AUDIT CALCULATIONS FOR A STATION BLACKOUT SEQUENCE
IN THE SURRY FACILITY

Accident Analysis Group
and
Experimental Modeling Group

January 10, 1985

ABSTRACT

Figure 1.1 Flow diagram of ASTPO codes for application to Surry.

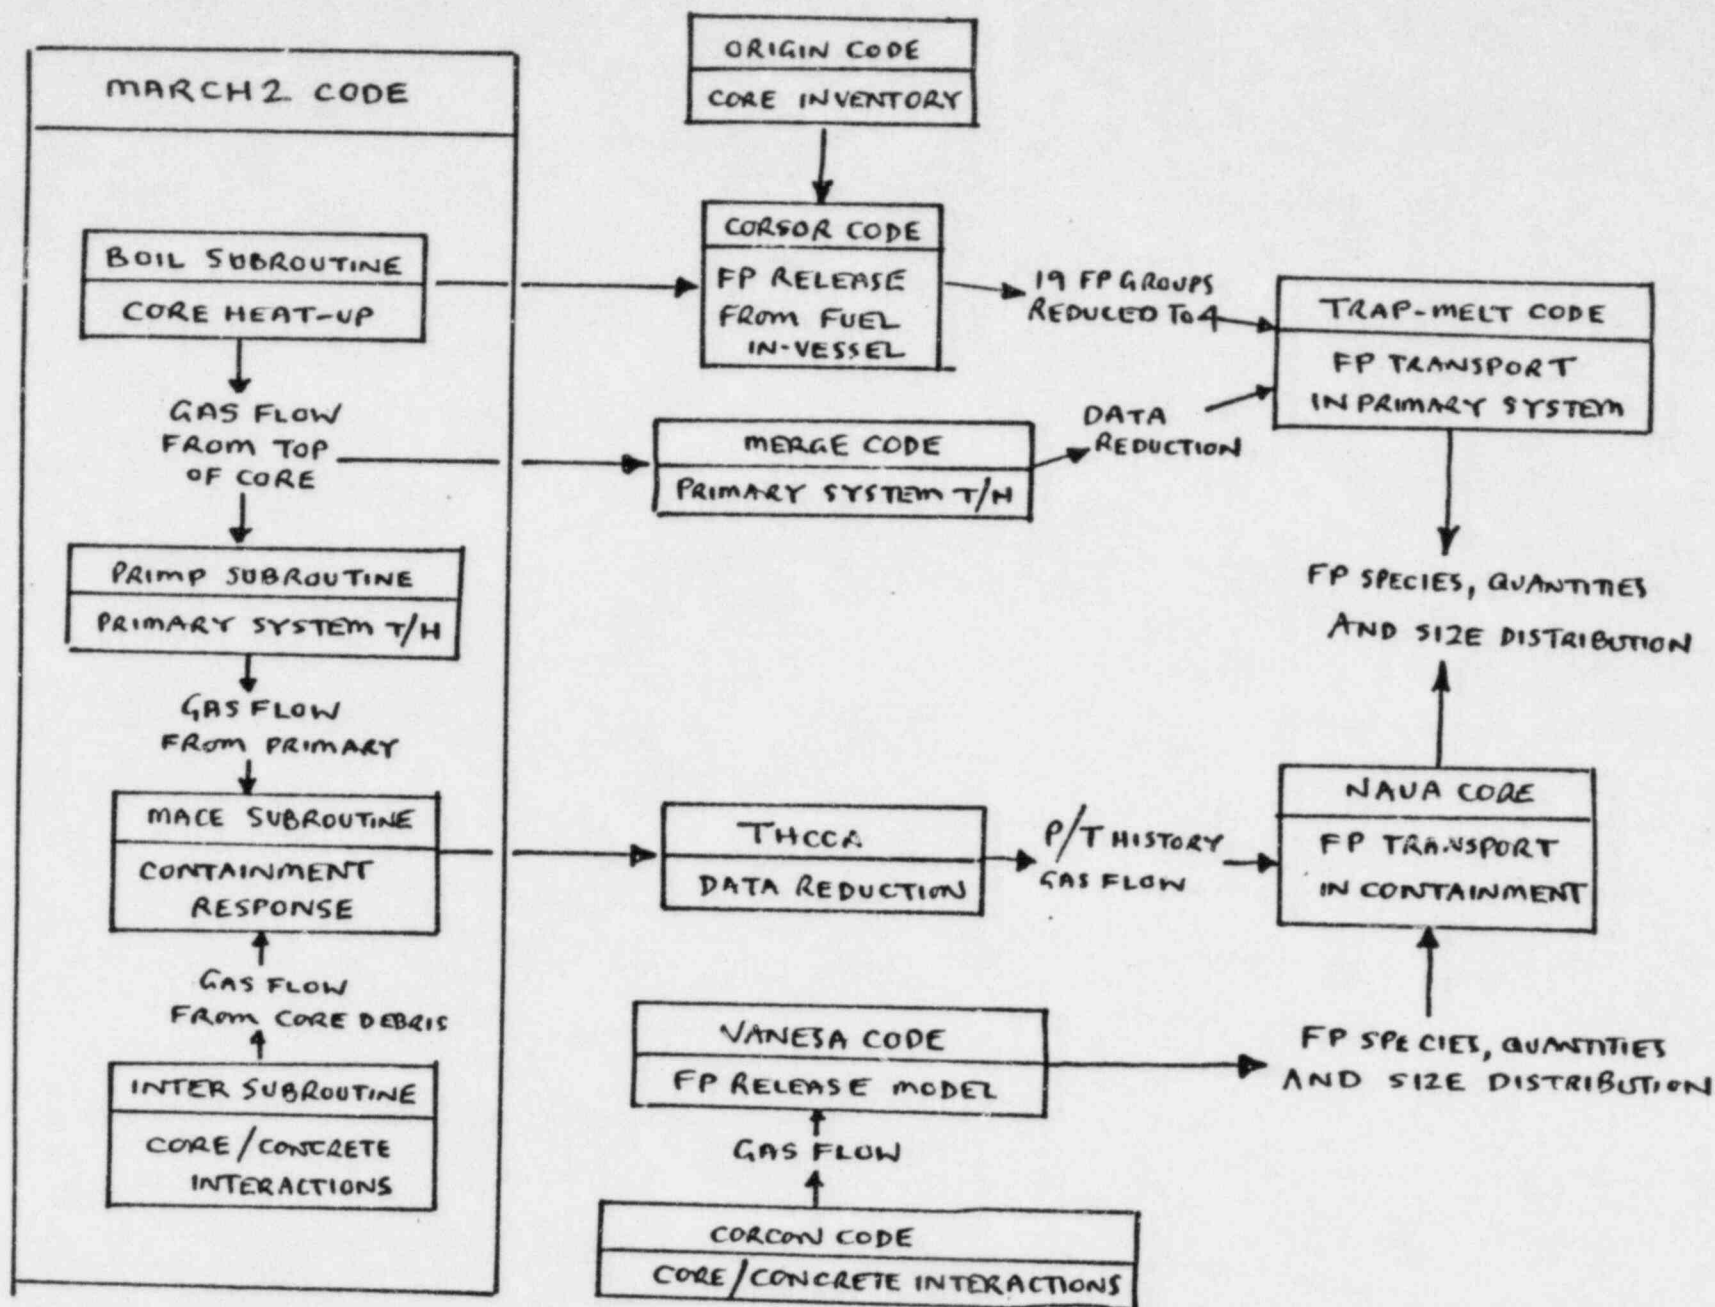
calculate primary system thermal hydraulics. Output from CORSOR and MERGE are used in the TRAP-MELT code to predict primary system transport of fission products. Fission product output from TRAP-MELT feeds the NAUA code, which calculates fission product transport in the containment building. Note that NAUA gets thermal hydraulic data from the MACE subroutine of MARCH. Inconsistency between these codes was noted as part of the initial peer review of BMI-2104. The flow rate predicted by PRIMP of MARCH is not consistent with the flow rate predicted by MERGE.

After head failure (HEAD subroutine) MARCH can model core debris/water (HOTDROP) or core debris/concrete (INTER) interactions depending on conditions in the reactor cavity beneath the reactor vessel. The thermal/hydraulic conditions in containment depend strongly on the mode of ex-vessel core debris interactions. If extensive core/concrete interactions occur then the associated fission product release must also be calculated, which is done by using the CORCON code (core debris/concrete interactions) together with the VANESA code (fission product release from ex-vessel interactions). The user of the codes should explicitly ensure that the start of core/concrete interactions predicted in the MARCH code is consistent with start of interactions assumed in the CORCON/VANESA codes. In addition, the user must be mindful of the inconsistency of using INTER to calculate the containment response (MACE) and CORCON/VANESA to calculate fission product release. This was also noted as part of the peer review of BMI-2104.

Figure 2.1 Melt temperature history vs. time: Surry TMLB' sequence.

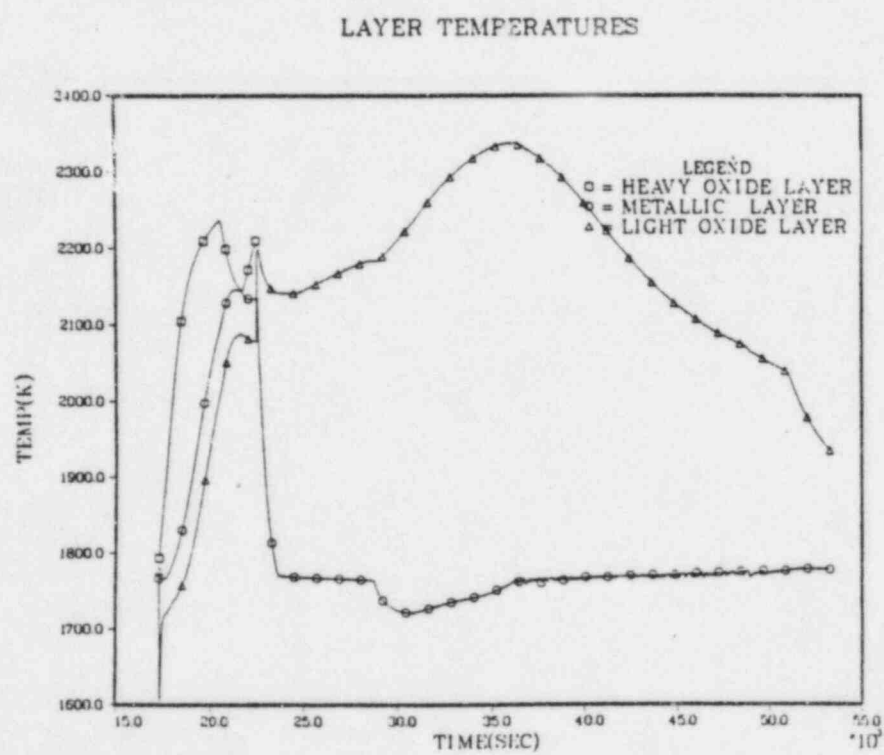
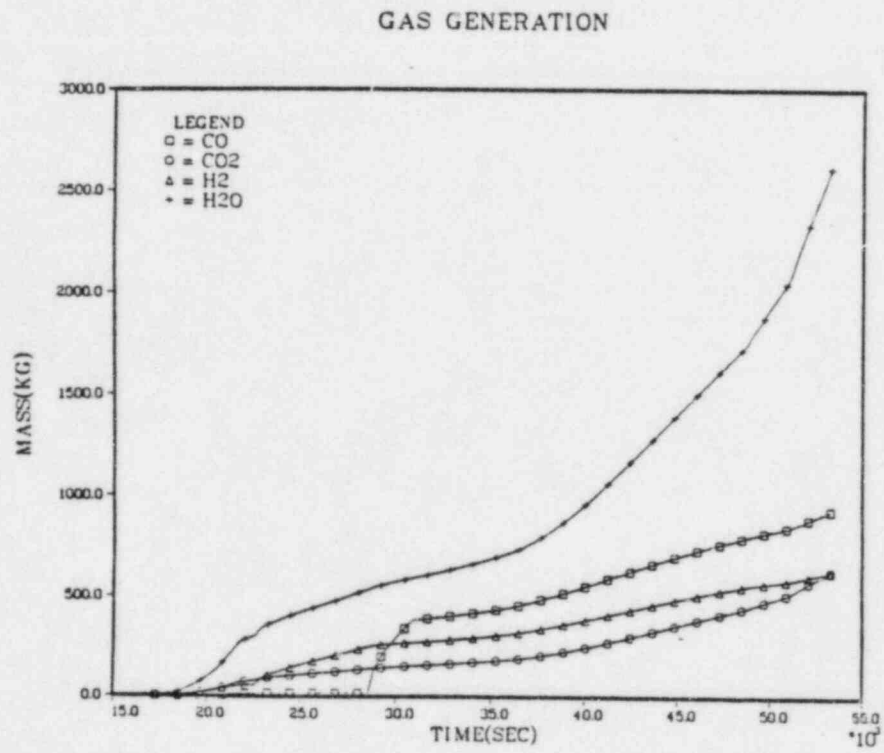
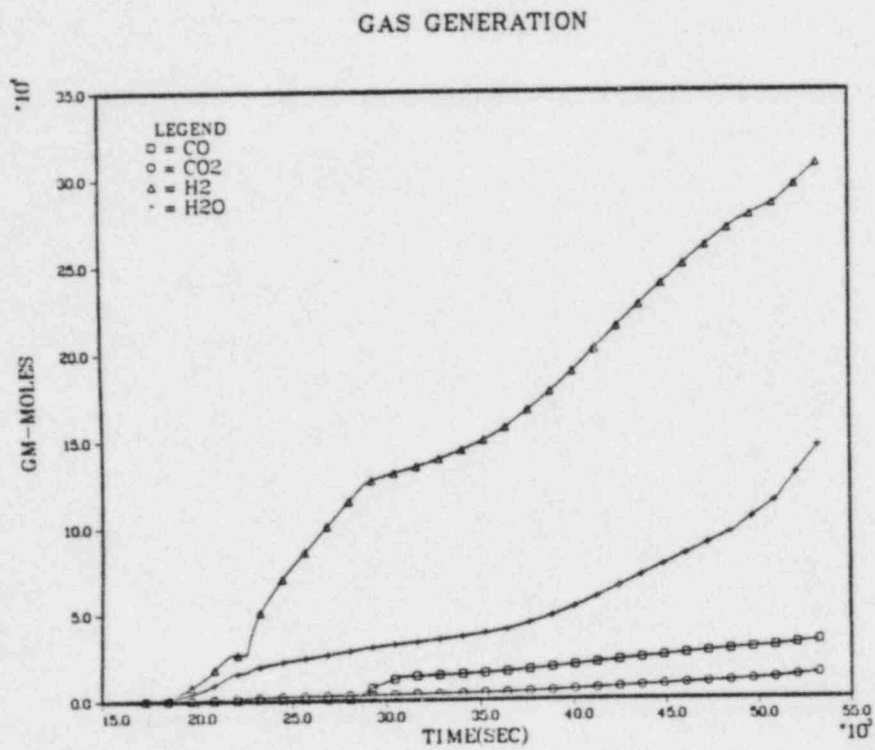
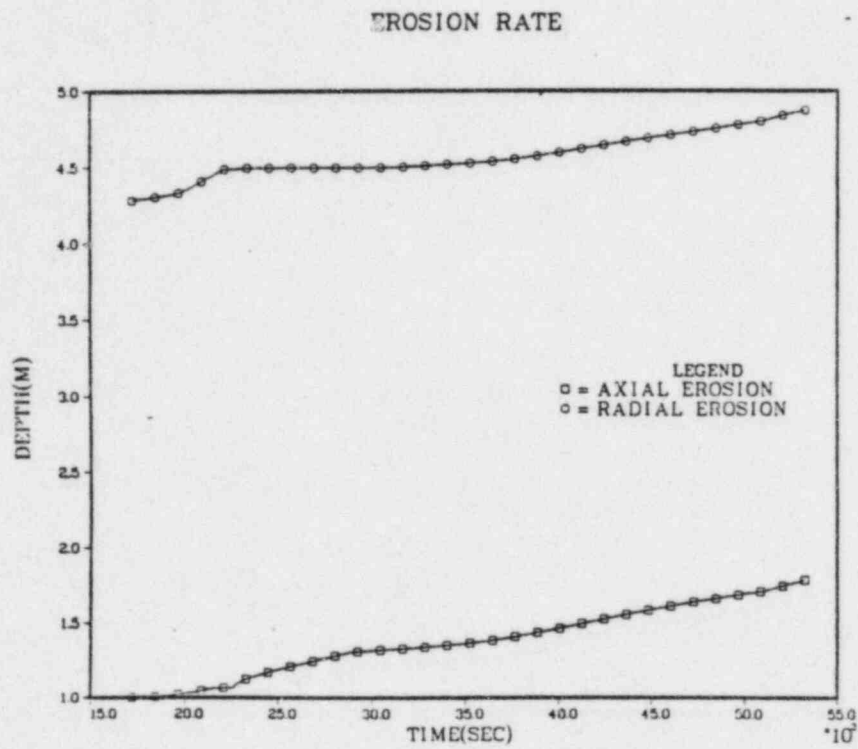
BMI-2104 Volume V, with the following exceptions. The SNL CORCON calculation was started at 157 minutes after SCRAM at an initial core debris temperature of 1807K and a time-invariant surroundings temperature of 500K. The BNL core/concrete interaction was started at 287 minutes after SCRAM with a time-invariant surrounding temperature of 1373K and initial melt temperature of 1777K. This was done to be consistent with the BNL MARCH calculation results of initial melt temperature, surroundings temperature and start of core/concrete interactions at 287 minutes after SCRAM (corresponding to the time INTER allowed core/concrete interaction to occur after adiabatic reheating from quenching). Both of the above core/concrete interaction calculations were performed at BNL and compared for differences. It was found that only minor differences were calculated in erosion rate, gas generation rates, and melt temperature vs. time.

The results of the CORCON/MOD1-C2 calculations are shown in Figures 2.1-2.4 as melt temperature history vs. time, integrated gas generation rates in kg and moles vs. time, and vertical and lateral erosion depths vs. time, respectively.

Figure 3.1 Airborne and leaked masses (Audit calculations).

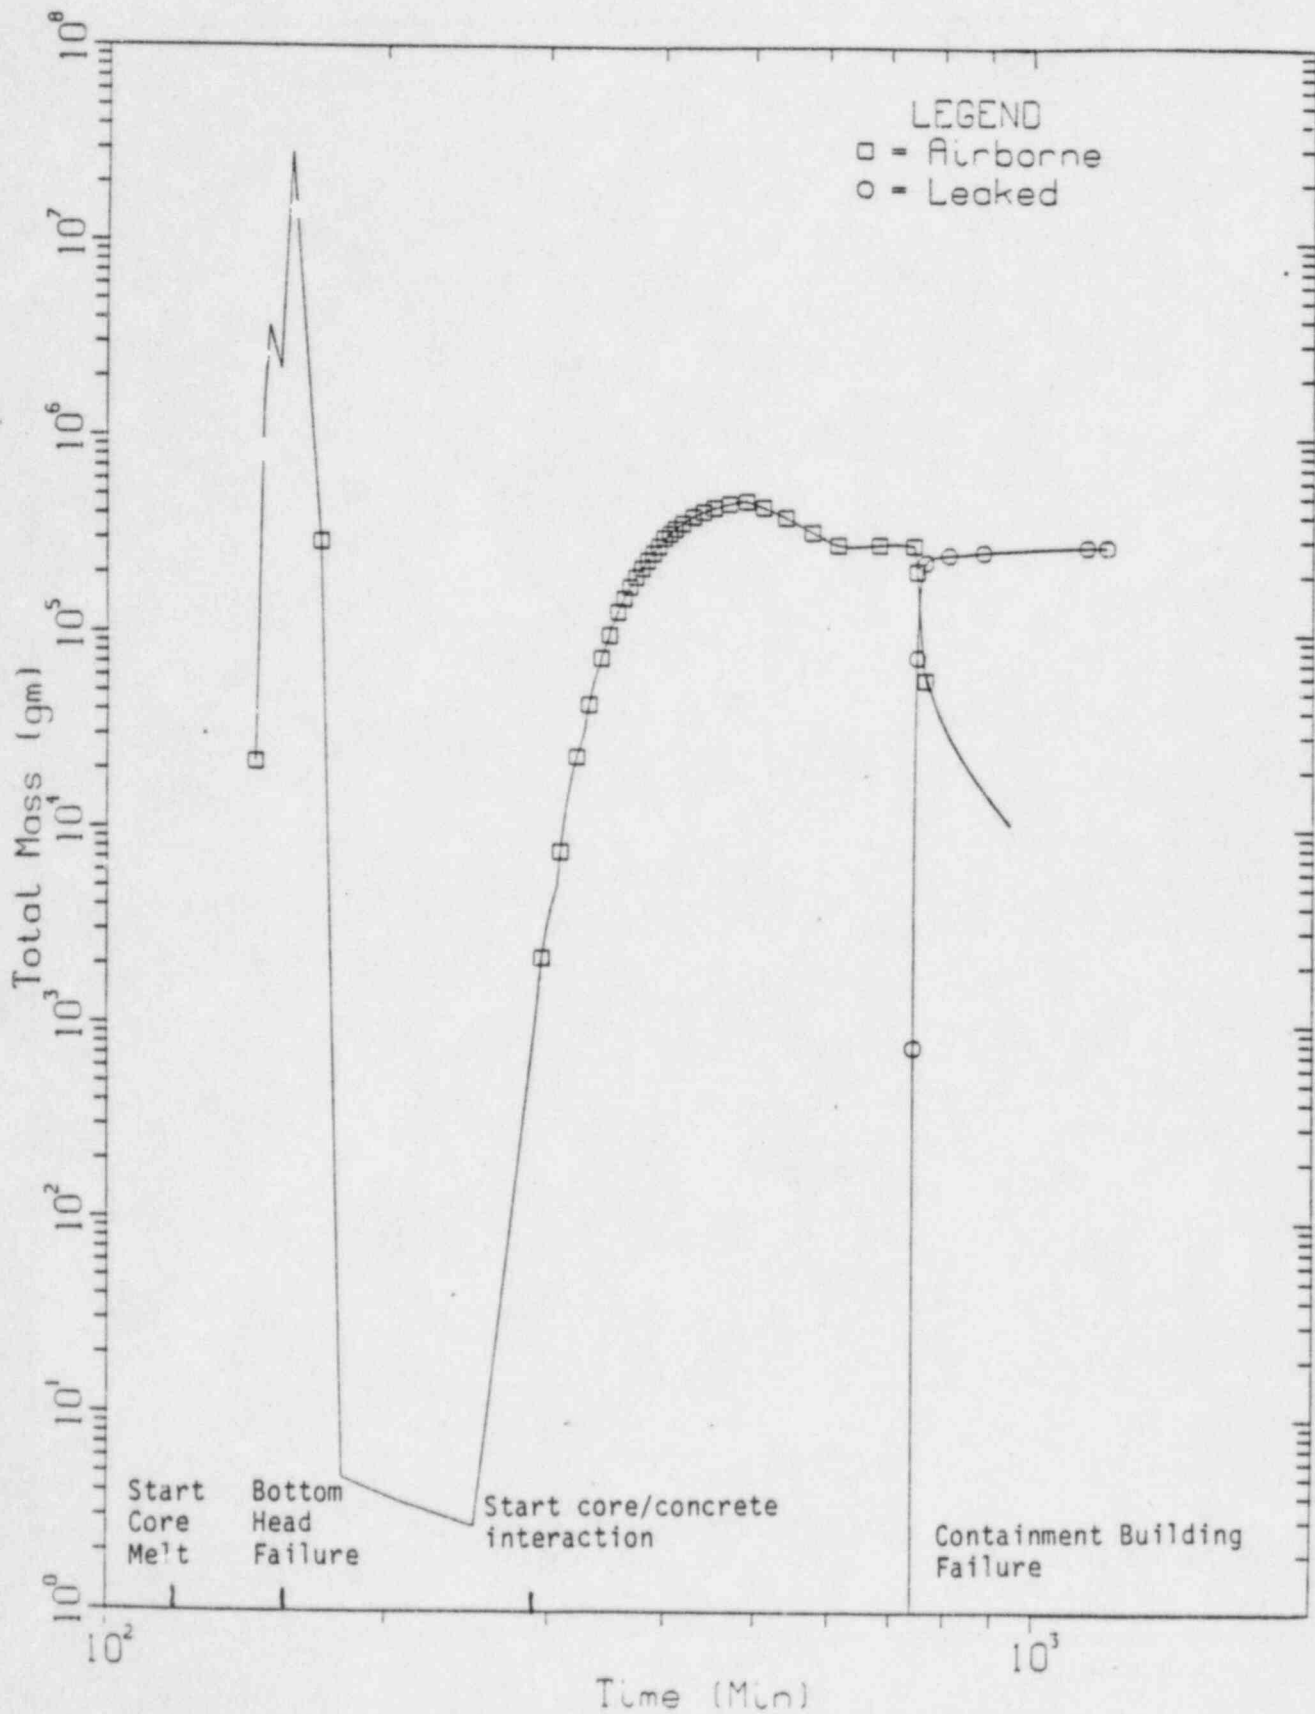
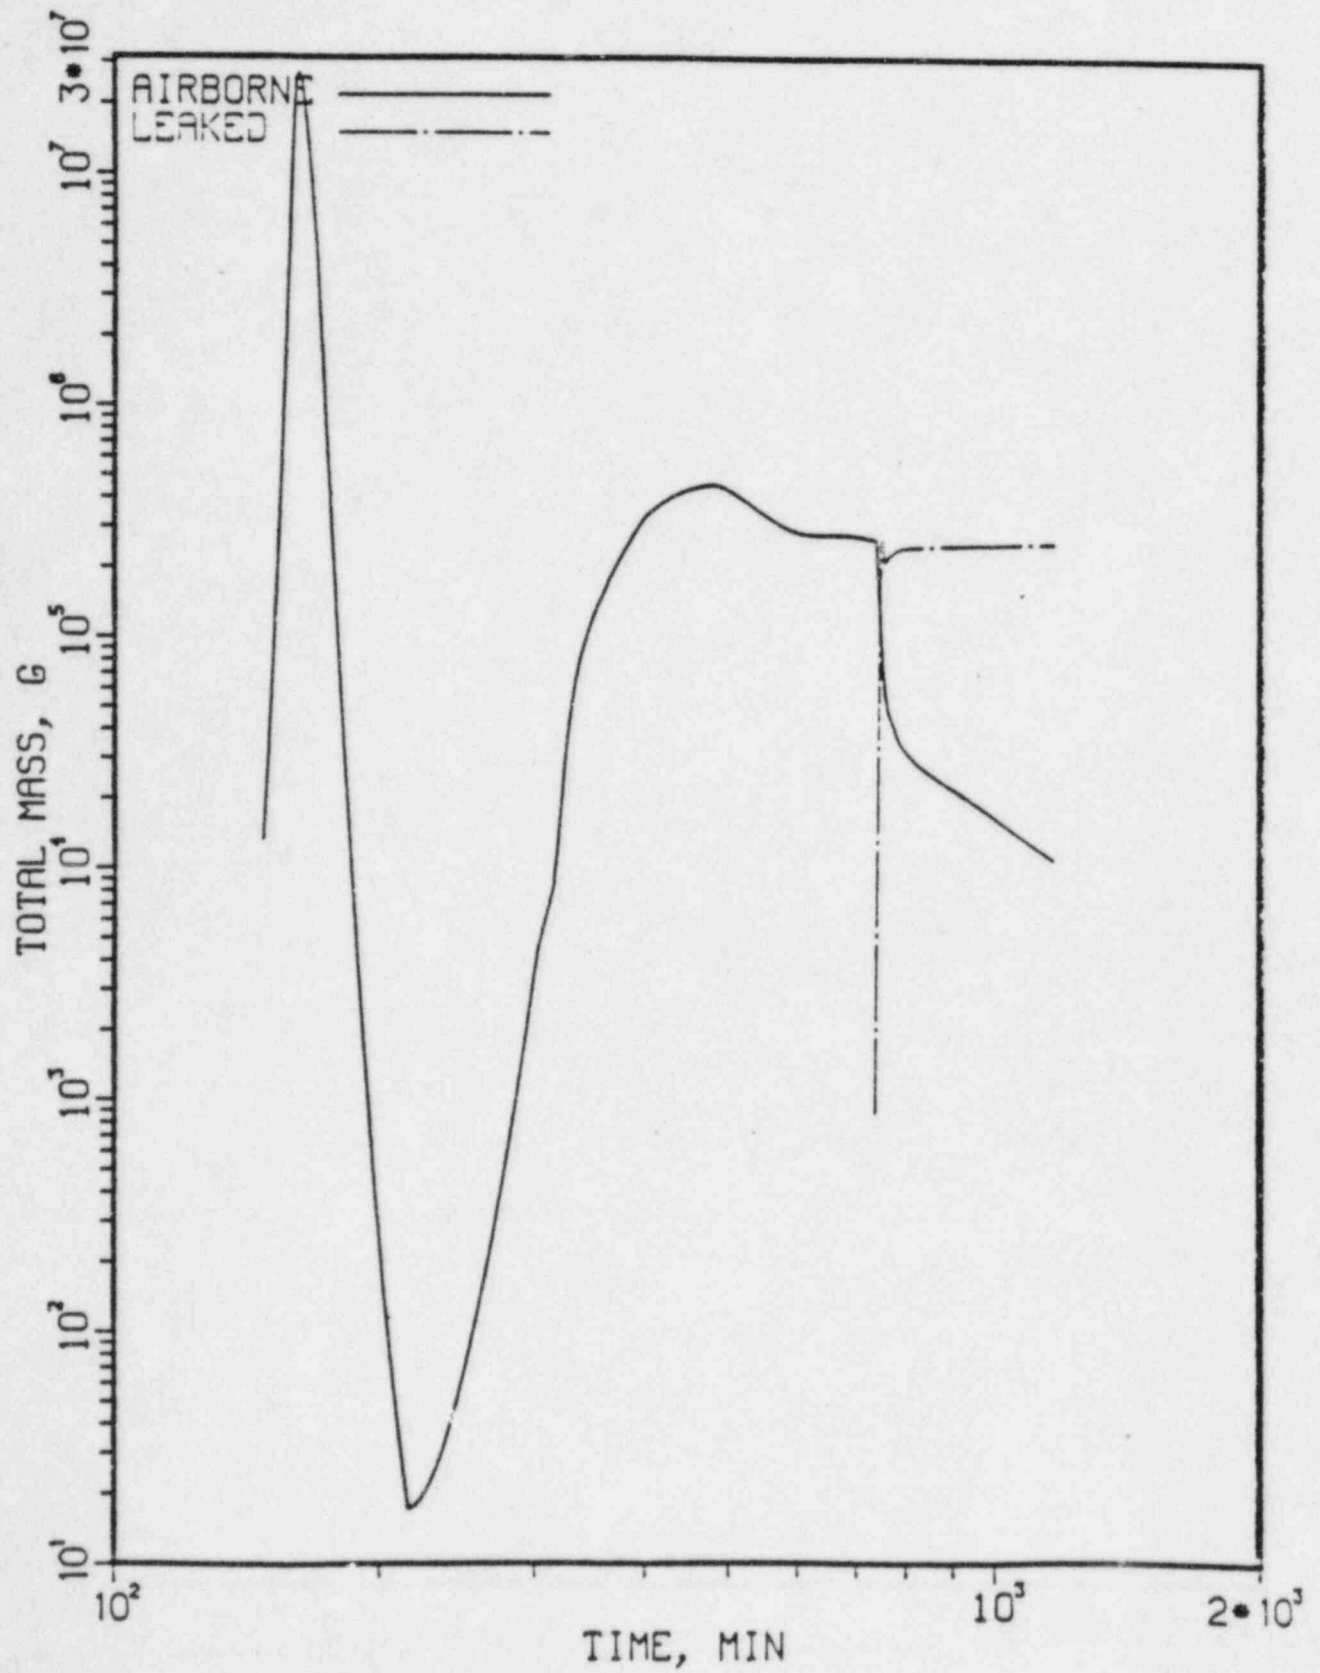
A final check between these two calculations is a comparison between the airborne and leaked mass as a function of time. Figures 1 and 2 illustrate this comparison. The audit calculation (Figure 1) and the BMI-2104 calculation (Figure 2) show the same trends and to a large extent the same magnitudes. The airborne mass peaks following vessel failure due to steam in the atmosphere. The peak values agree well between the calculations. A valley develops as the steam condenses, and aerosols due to core/concrete interactions have not been generated yet. The valley in the audit calculation is

deeper than in the BMI-2104 calculation. However, the remainder of the curve starting at the beginning of core/concrete interactions agrees well with the BMI-2104 curve. Following containment failure the BNL curve predicts a sharp decrease.
